City of Richmond
Urban Development Division

Report to Development Permit Panel

Date: June 7, 2004
File: DP 04-263971

Re: Application by Rocky Sethi for a Development Permit at 8200 Williams Road

DP 04263971
JUN 30 2004
PLAN # 1

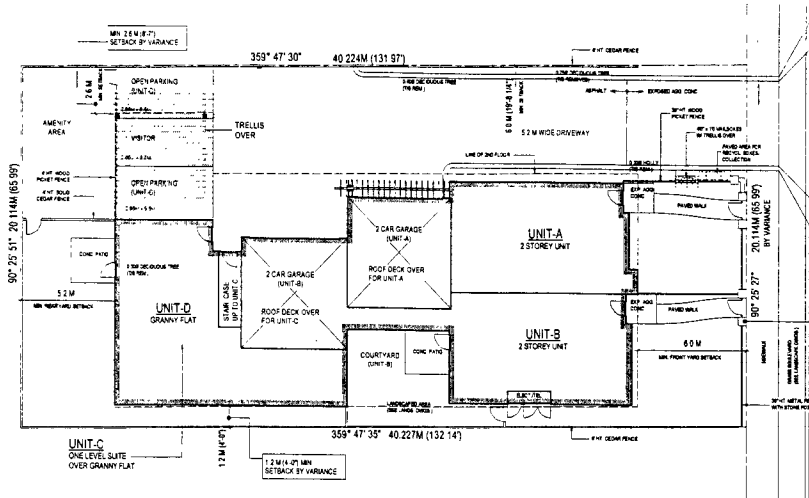
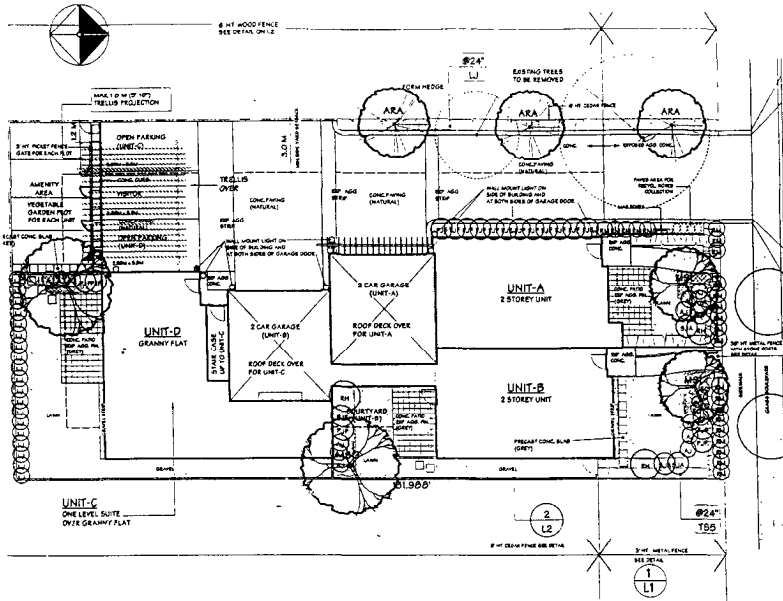
- 1) To vary the provision of Section 203.4 (Minimum Setbacks from Property Lines) of the 203 Townhouse District (R2) Zoning Schedule in Division 200 (Zoning District Schedules) to reduce the minimum required side yard setback from 3 m to 2.75 m for the trellis structure at the west property line and 1.2 m for the building at the east property line.

(Staff supports the variances as they are a result of the transition being provided on this small site between the adjacent three-storey apartment building development existing single-family homes to the east and south. The reduced side yard setback to the east adjacent to an existing single-family home was identified in the rezoning staff report and was considered consistent with single-family type housing. The site has been designed with the driveway along the west edge of the site adjacent to the apartment building in order to minimize the impact of the development on the single family lot to the east. The site layout also attempts to provide a transition by creating a low density townhouse development with an animated streetscape, shared auto court and screened parking, thus affecting the side yard setbacks. The trellis structure is a positive element to enhance the interface with the adjacent apartment building through screening the view of the surface parking from overhead).

- 2) To vary the provision of Section 203.6 (Minimum Lot Size) of the Townhouse District (R2) Zoning District Schedule in Division 200 (Zoning District Schedules) to reduce the minimum required lot width from 30 m to 20.1 m.

(Staff supports the proposed variance which was identified in the rezoning staff report, in recognition of the transition being provided on this small site between an existing single family home and three-storey apartment building development).

- 3) To vary the provision of Section 407 (Parking Spaces Required) of Division 400 (Off-Street Parking & Loading) to reduce the minimum required number of parking spaces per dwelling unit for townhouses in Townhouse District (R2) from 2.0 to 1.5 spaces per dwelling unit.

(Staff supports the proposed variance, as it is consistent with requirements for multiple-family dwellings in other zoning districts; in recognition of the public benefit being provided with a universally accessible unit in this small development; and in recognition of the transition being provided on this small site between an existing single-family home and three-storey apartment building development).

Variations Requested: * Variations have been requested to reduce the minimum required side yard setback from 3 m; to reduce the minimum required lot width from 30 m to 20.1 m; and to reduce the required resident parking spaces from 8 to 6. The proposed side yard setbacks are as follows: 2.75 m for the trellis structure at the west property line and 1.2 m for the building at the east property line. (see attached Plan #1).

DP 04263971
JUN 30 2004
PLAN # 2

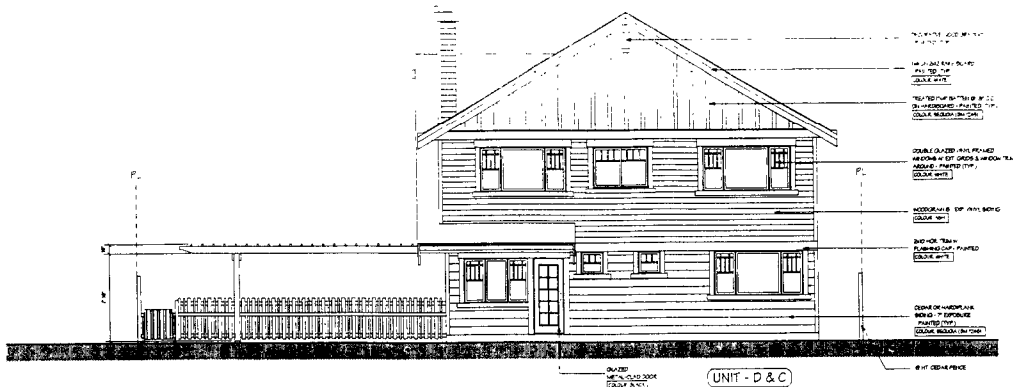
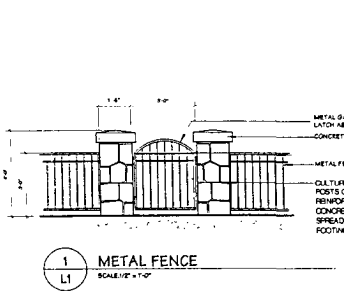
- ❖ they liked the project;
- ❖ the vegetable garden was a very good idea;
- ❖ there was a narrow landscaped strip between driveways – could this be screened either by a hedge/fence, bamboo or shrub;
- ❖ they were concerned that any additional tall planting blocking light to the proposed *peris*;
- ❖ real stone should be used on the chimney, otherwise it would impact negatively on the project;
- ❖ the size of the accessible parking stall was not wide enough it should be at least 3.7 meters wide;
- ❖ a possible solution to the narrow strip might be columnar trees and an appropriate sized fence; and
- ❖ a bench type seating area should be placed in the amenity area.

In summary, Chair stated that the narrow planting strip could be improved with taller columnar tree forms, the accessible parking stall should be widened to the appropriate size and the masonry should be of high quality. Vines should also be planted on the trellis.

1. Improve the narrow planting strip including trees with some height. *Three new maple trees will be planted to compensate for the loss of the existing substantial tree;*
2. look at the possibility of widening the accessible parking stall to the appropriate size. *The parking space for the accessible unit has been located to provide a configuration which is more accessible;*
3. ensure that masonry for the chimney is of high quality material. *A high quality cultured stone veneer will be used from a local manufacturer;* and
4. vines are planted on the proposed trellis - *incorporated.*

- Three (3) trees are being removed and replaced with seven (7) trees. An additional tree is being removed as it is a safety hazard. The new trees are incorporated into a landscape design and include three (3) Maple trees with 10 cm calliper to compensate for the removal of a major Sycamore Maple tree. Unfortunately, a registered arborist has advised that it is not viable to retain this major tree due to its proximity to the proposed driveway and required site grading works. The existing tree may become a safety hazard and would ultimately need to be removed later; and
- The landscape design includes new shade trees along the driveway, special paving treatment with exposed aggregate, a communal vegetable garden with benches, as well as carefully considered planting and trees to provide a highly liveable environment along this arterial road.
